# **Conceptual Site Plan Brightseat Industrial**

STAFF RECOMMENDATION
<ul> <li>With the conditions recommended herein:</li> <li>APPROVAL of Conceptual Site Plan CSP-22003</li> <li>APPROVAL of Type 1 Tree Conservation Plan TCP1-021-2022</li> </ul>
,

SUBJECT: Conceptual Site Plan CSP-22003

Type 1 Tree Conservation Plan TCP1-021-2022

# **CONCEPTUAL SITE PLAN**

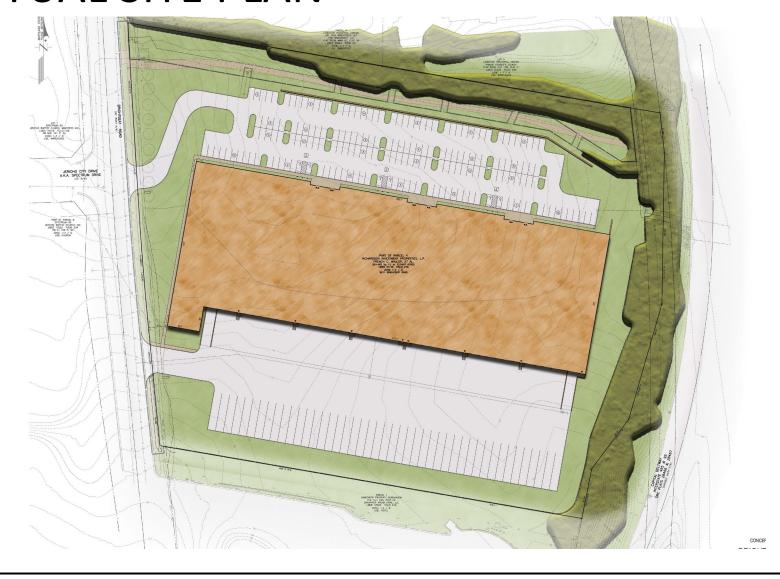
The latest CSP submission shows the extent of the ultimate right-of-way, along the property's frontage, consistent with the master plan's recommendation. Staff find the CSP acceptable, but recommends that 40 feet of right-of-way dedication from the centerline be shown on the subsequent PPS application.

The applicant has indicated intent to install shared-lane (sharrows) markings along Brightseat Road, instead of the recommended dedicated bike lane, unless otherwise modified by the Prince George's County Department of Permitting, Inspections and Enforcement. Staff does not support the modification to install sharrows, as this will change the functionality of the recommended master plan facility as a separate continuous/uninterpreted bike lane, which was not considered and adopted by the County Council. Furthermore, staff is concerned about the safety implications of a shared roadway, along this section of Brightseat Road, which will have an ultimate configuration of a four-lane collector roadway that will support a high volume of vehicular traffic. A dedicated bike lane would provide the necessary separation for vehicles and bicyclists and would facilitate safe mobility for nonmotorized travel, as designated in the MPOT. Installation of the bike lane will also be consistent with pending and approved developments near the site. For these reasons, staff recommend that a bicycle lane be installed, along the subject property's frontage of Brightseat Road, and be shown on the subsequent DSP.

In addition, to facilitate the master plan policies for pedestrian connectivity, staff recommend that a minimum 6-foot-wide sidewalk be provided along the perimeter of all buildings and that crosswalks are provided to facilitate pedestrian connections with the parking area and proposed buildings.

- 2. At the time of preliminary plan of subdivision, the applicant and the applicant's heirs, successors, and/or assignees shall show a minimum of a 40-foot right-of-way dedication from the centerline, along the property's frontage of Brightseat Road.

- b. A bicycle and pedestrian plan, which displays the details, location, and extent of the following facilities:
    - (1) A marked bicycle lane along the subject property's frontage of Brightseat Road, unless modified by the operating agency with written correspondence.

- (2) A minimum of a 6-foot-wide sidewalk along the perimeter of all buildings.
    - (3) Crosswalks and striping that provide pedestrian connections from the parking area to the building(s) on-site.

# TYPE I TREE CONSERVATION PLAN

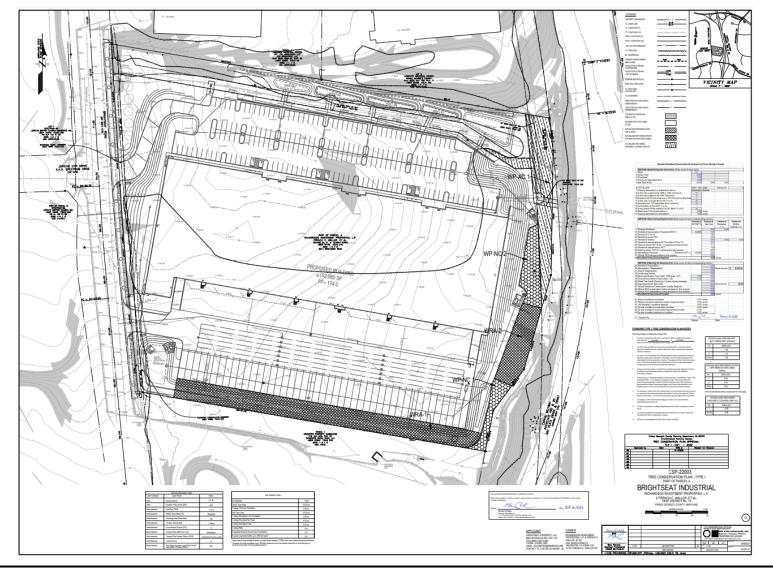
- 1. Prior to certification of approval of the conceptual site plan (CSP), the Type 1 tree conservation plan (TCP1) shall be revised, as follows:
  - a. The stormwater facility within the landscape buffer, along the southern boundary, shall be relocated for the landscape credits to count toward meeting the woodland conservation requirement on-site.

- b. Revise the plan to show the layout of the area where landscape credits will be used, along the southern property line .
  - c. Revise the worksheet to show landscape credits being used.

- d. Correct Note 10 of the standard Type 1 conservation plan notes, the correct section number is 25-119.
  - e. Have the plans signed and dated by the qualified professional who prepared them.
